14 December 2012  
File No. 38706-119

**Re: Response to Request for Information dated November 8, 2012  
Class III Underground Injection Control (UIC) Well Permit Application  
Curis Resources (Arizona) Inc.**

Figure 9-1 (REVISED 12062012)  
Model Predicted Migration of Lixiviant – Scenario 8  
West-facing Cross Section  
Florence Copper Project Groundwater Model

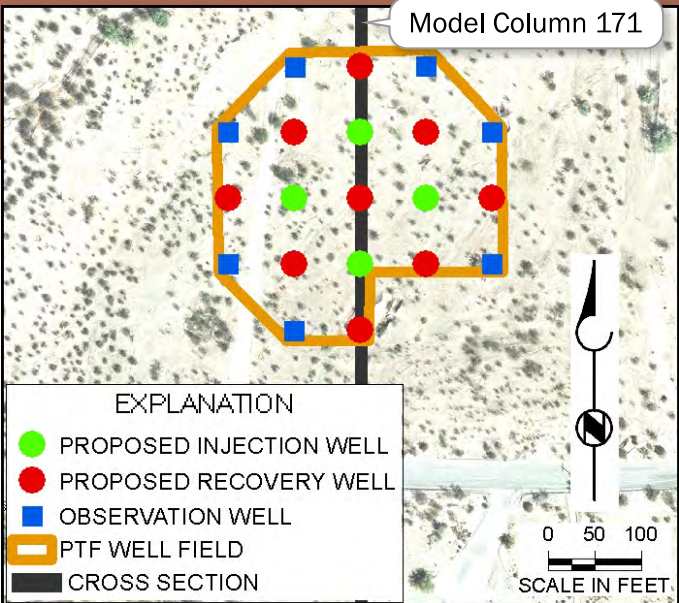
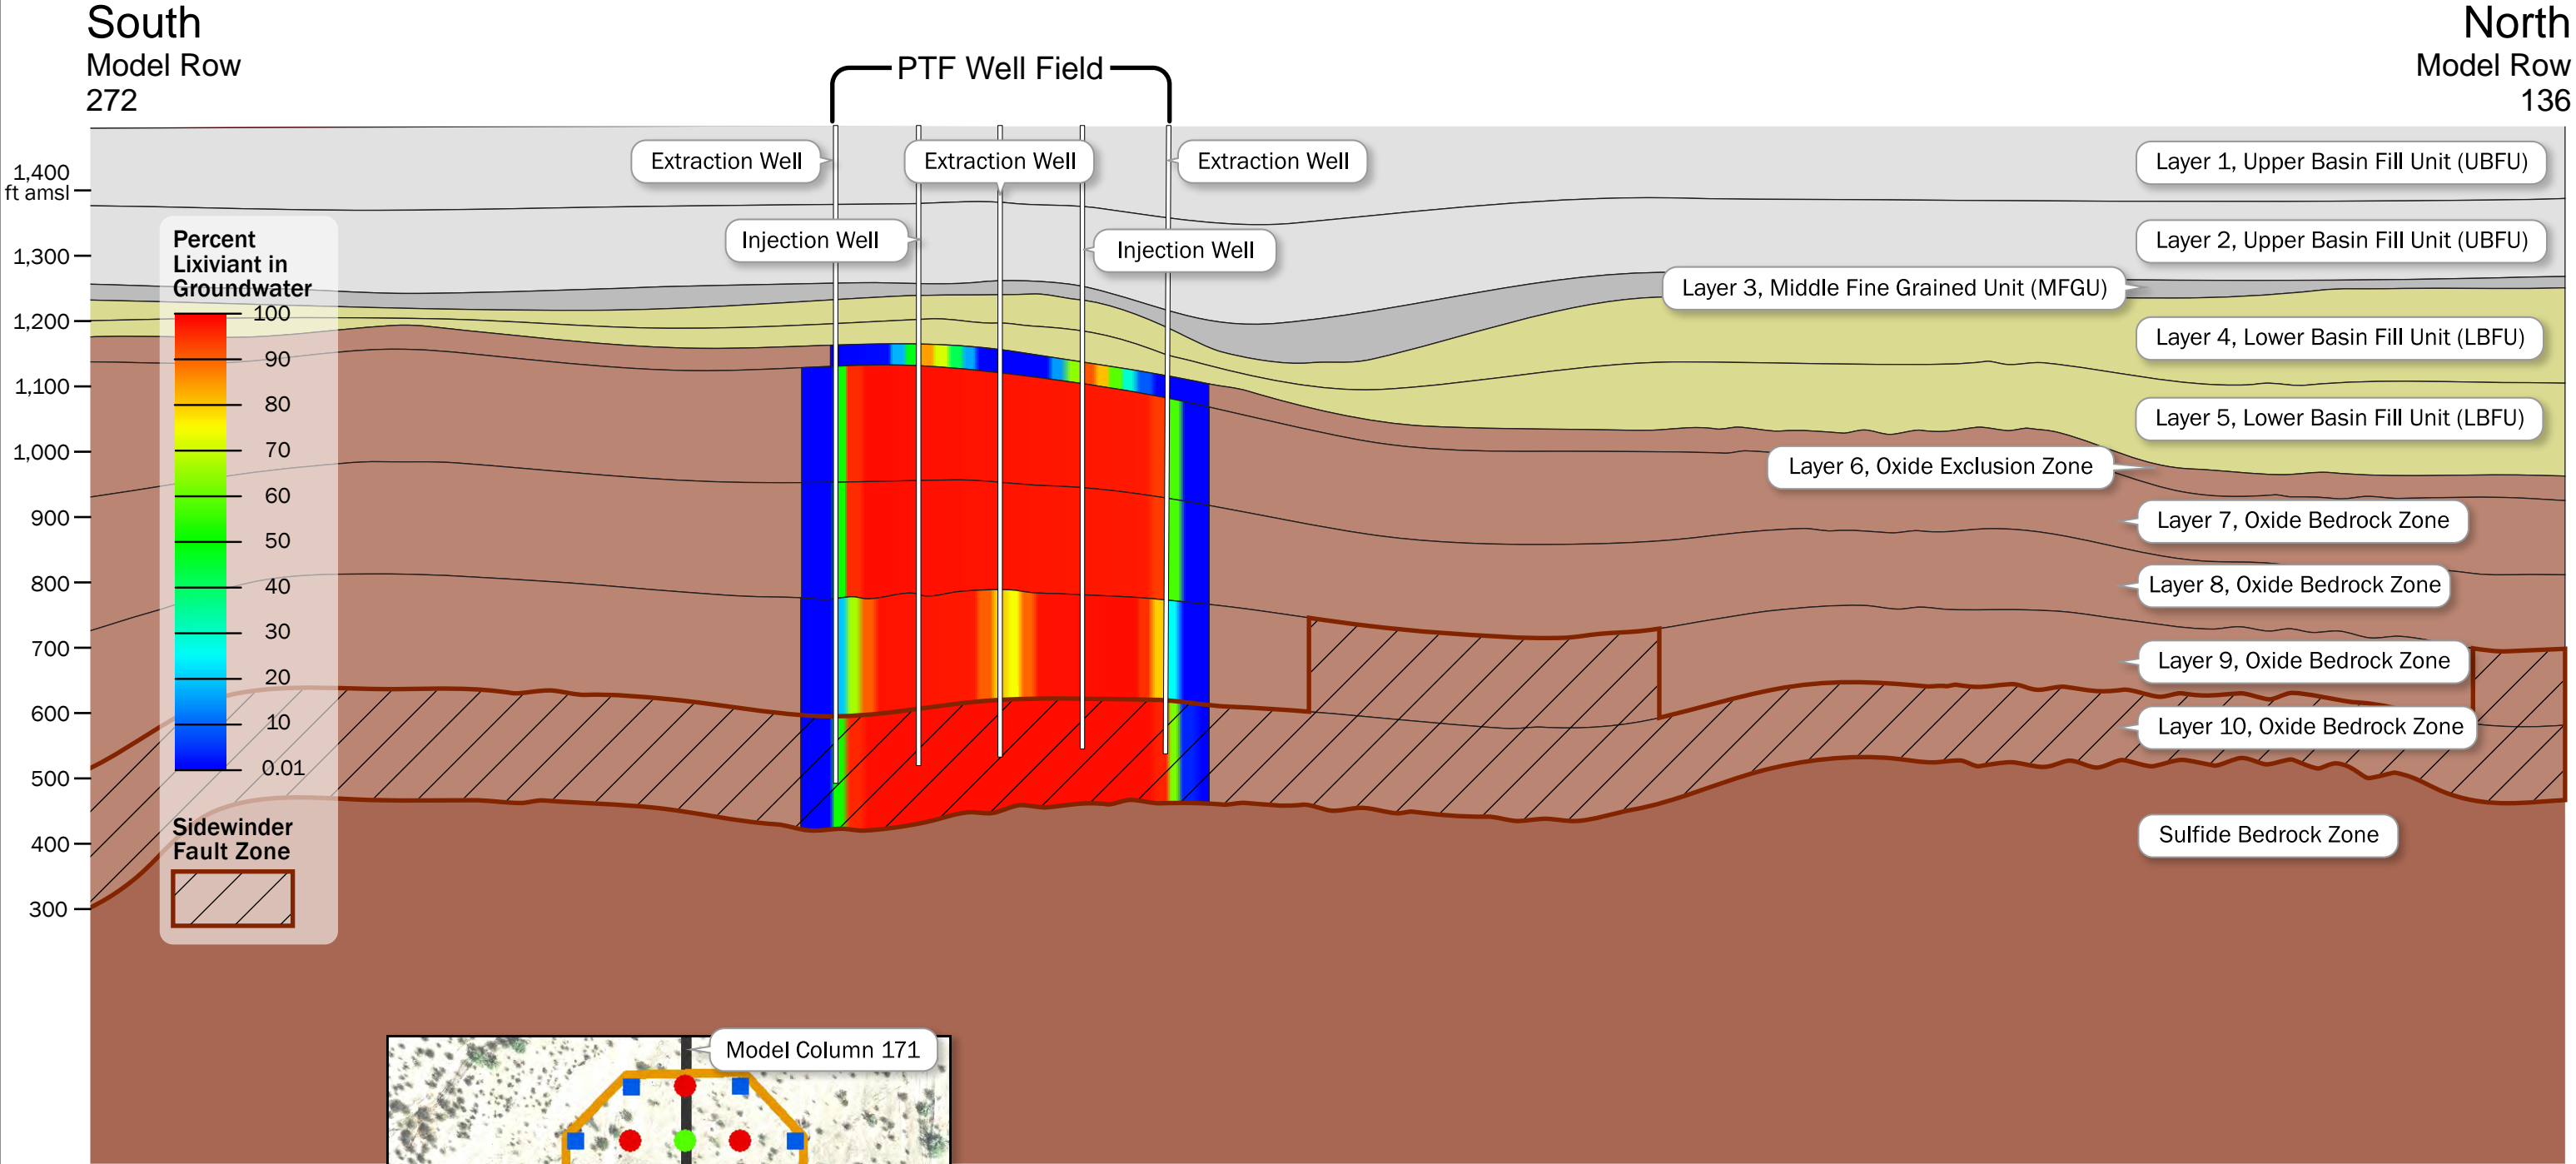
8. *Native Fluid Displacement: The response is generally acceptable except that the discussion of vertical migration of lixiviant is somewhat inconsistent with the illustrations in Figures 9-1 and 9-2. The discussion on page 15 states that injected fluid is simulated to migrate upward approximately 40 feet into the exclusion zone and approximately 54 feet into the lower basin fill unit (LBFU), but no migration into the LBFU is shown in Figure 9-2.*

*Please explain why no migration is shown to occur into LBFU in the westward view in Figure 9-1 but does occur in the northward view of the PTF.*

A revised version of Figure 9-1 is included in Attachment 1. Figure 9-1 was revised to show the limits of the PTF well field as defined above in the response to Comment 1. A revised version of Figure 9-2 is also included in Attachment 1. Figure 9-2 has been revised to reflect the assumed continuous nature of the Sidewinder fault as described above in response to Comment 7.

“Figures 9-1 and Figure 9-2 provide cross-sectional views of the extent of vertical migration of injected fluid under steady state injection and recovery conditions at the end of a 14-month period of operations. As shown on Figure 9-1, which represents a west-facing cross-sectional view, injected fluid migrates upward approximately 40 feet into the exclusion zone after 14 months of operating conditions, and does not reach the LBFU along this transect. Figure 9-2 provides a north-facing cross sectional view of the extent of vertical migration at the end of PTF operations. Along this west-to-east transect, injected fluid is simulated to migrate upwards approximately 40 feet into the exclusion zone **and does not reach the LBFU along this transect** ~~and approximately 54 feet into the LBFU, within a very limited lateral extent.~~ In summary, model results indicate that mounding of injected fluid is limited to the 40-foot thick exclusion zone, but trace concentrations of injected fluid occur in the LBFU above the injection area as a result of dispersive effects.”

Figure 2-1 (REVISED 12062012)  
Model Predicted Migration of Lixiviant – Scenario 1  
Florence Copper Project Groundwater Model

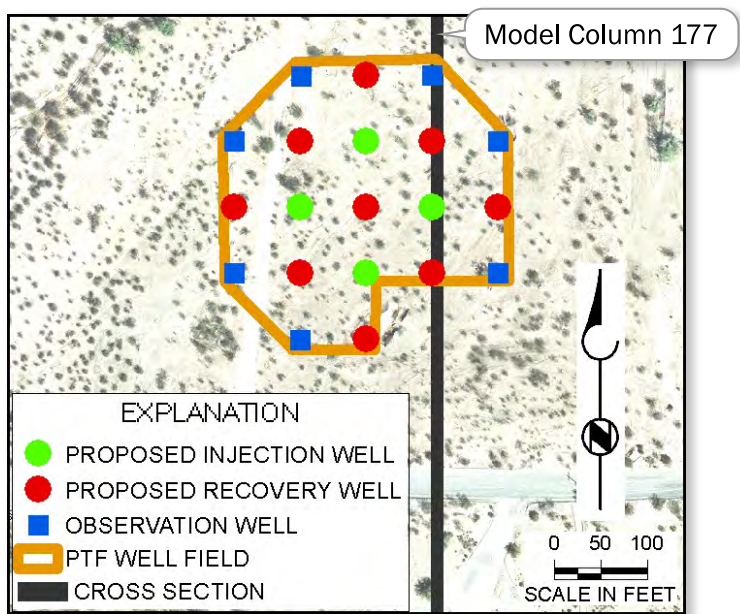
2. *A.3, MODFLOW IMT3D Groundwater Model and Simulation Results: The Curis Arizona response to Comment 2 of our July 2012 letter, regarding the modeling results for assessment of hydraulic control, does not address the question of the extent of vertical movement of the lixiviant within the Sidewinder and other fault zones with lack of hydraulic control for 48 hours and up to 30 days. Figures 2-1 to 2-8 depict fluid movement horizontally in the fault zone in a north-south view across the PTF, but none of the figures show the fault zones in an east-west cross sectional view that could illustrate the extent of vertical fluid movement within the fault zones. The extent of vertical flow within the 10 layers is shown in the figures, but not within the Sidewinder fault zone and other intersecting faults. It is possible that lixiviant could migrate up dip within the more permeable fault zones for a lateral distance exceeding the 500-foot AOR and upward into the LBFU where the faults intersect the contact between the LBFU and Bedrock Oxide Zone.*

*Please provide a discussion and illustrations of the extent of vertical migration of lixiviant within the fault zones under the conditions presented in the responses to Comment 2. Cross-sectional views in an east-west orientation, similar to the cross section in Figure 9-2, should be provided for that purpose.*

Figures 2-1 through 2-8 (north-south cross sections) have been revised to reflect the PTF well field area defined above, in response to Comment 1. An additional set of east-west oriented cross sections corresponding to Figures 2-1 through 2-8 have been created and are included as Figures 2-1a through 2-8a. Figures 2-1 through 2-8 and 2-1a through 2-8a depict the extent of migration of injected fluid under conditions defined in the RFI dated January 30, 2012. These conditions were simulated as permutations of the base model which are described in Table 2-1. Figure 2-1 through 2-8 and 2-1a through 2-8a are provided in Attachment 2.

Figure 2-1 provides a cross-sectional view (north-south transect) of vertical and horizontal migration of sulfate from a single well within the PTF well field after operating without hydraulic control for a period of 30 days, and using the fault hydrologic parameters described above. Under these simulated conditions, injectate migrates northward approximately 201 feet horizontally from the PTF injection well, and approximately 40 feet vertically into the exclusion zone. Figure 2-1a shows that injected solution migrated approximately 150 feet to the west in model layer 10. Injected solution did not reach the LBFU in significant concentrations after 30 days without hydraulic control. The estimated horizontal migration distance of 201 feet was the maximum observed from all model scenarios and associated simulations involving 30-day lixiviant injection without hydraulic control.

<b>HALEY &amp; ALDRICH</b>	CURIS RESOURCE (ARIZONA) INC. FLORENCE, ARIZONA
<b>MONITOR WELL LOCATIONS PROPOSED TEST FACILITY</b>	
<b>HDI CURIS</b>	SCALE: AS SHOWN NOVEMBER 2012
<b>FIGURE 11-1</b>

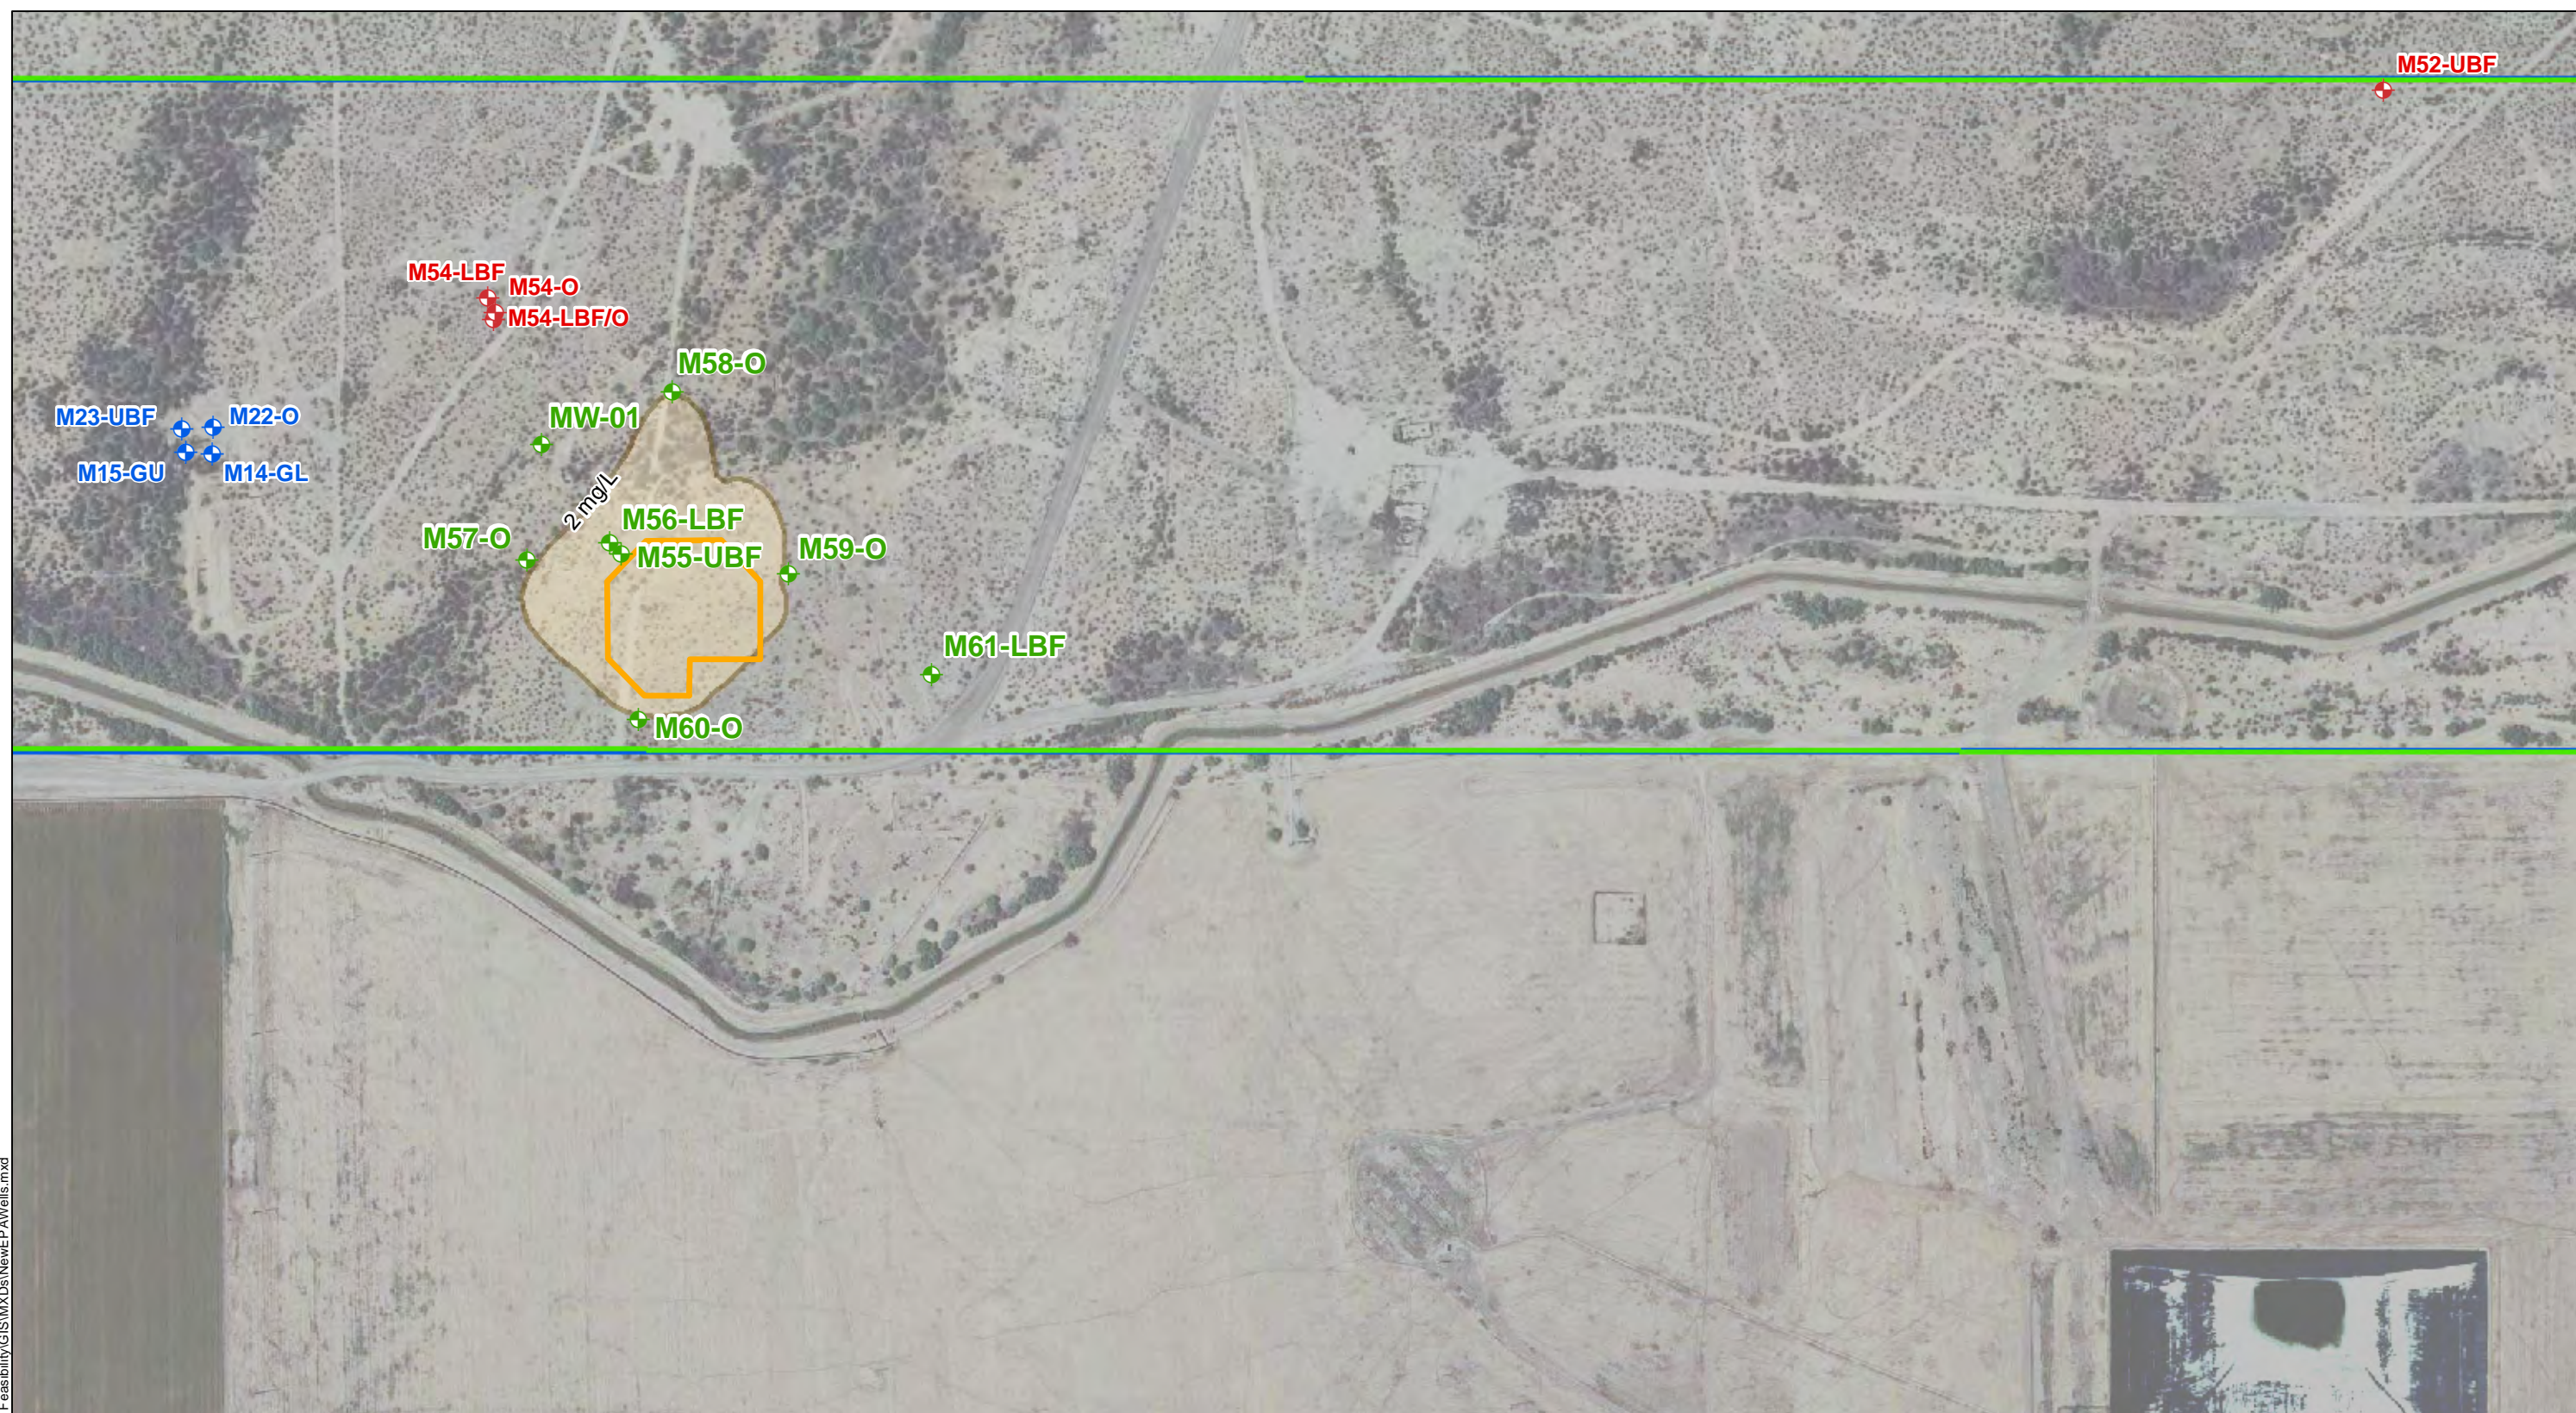
*11. Demonstration of Hydraulic Control: Please provide a proposed plan for an additional monitoring well in the lower 200 feet of the LBFU to the east of the PTF and above the area where Sidewinder fault and other faults meet the Oxide-LBFU contact. The recommended location is approximately 300 feet east of the outer recovery wells on the eastern perimeter of*

*12. Additional Monitoring in the Oxide Zone: Please provide a proposed plan for additional monitoring wells: one each at the most northern, western, southern, and eastern extent of the 2 mg/L contour in Figure 14A-37, labeled "Extent of Sulfate Migration within the Oxide (All Layers) 5 Years after Closure". All of these wells should be screened in the Oxide injection zone. The northern well would be screened in the Sidewinder Fault Zone where it intersects the Oxide Zone to monitor preferential flow down gradient in the fault zone. Please confirm that coincides with the northernmost extent of the predicted sulfate migration since the Sidewinder Fault Zone is apparently aligned in that position and direction at the Oxide depth in the PTF project area. The southern well would also be placed and screened where the Sidewinder Fault Zone intersects the Oxide Zone. The distance of each well from the well field will vary from approximately 50 feet to 300 feet depending on the position of the 2 mg/L contour relative to the well field. These well locations will serve to assess the accuracy of the predictive simulations for sulfate migration five years after closure and monitor for loss of hydraulic control during PTF leaching operations.*

Curis Arizona herein proposes to install a supplemental monitor well (M61-LBF) located approximately 350 feet east of the PTF Well Field. The proposed location of M61-LBF is shown on Figure 11-1 (Attachment 4). Based on the SRK Geologic model, the LBFU is at its maximum thickness of 335 feet at this location, extending to 635 feet below ground surface. The aquifer exemption extends 200 feet into the LBFU; the portion of the LBFU that is above the aquifer exemption boundary is required to be protected as a USDW. This proposed well will provide a monitoring point to ensure the protection of the upper LBFU as a USDW. M61-LBF will be screened across the bottom 200 feet of the LBFU; a proposed well design is included as Figure 11-2 (Attachment 4).

Curis Arizona herein proposes a plan to install four supplemental monitor wells around the PTF well field. The proposed well locations are based on the most northern, eastern, southern, and western extent of the 2 mg/L contour of the "Extent of Sulfate Migration within the Oxide (All Layers) 5 Years After Closure" as shown on Figure 14A-37 of the Temporary APP application. The well locations are shown on Figure 11-1 (Attachment 4), along with the 2 mg/L sulfate migration contour.
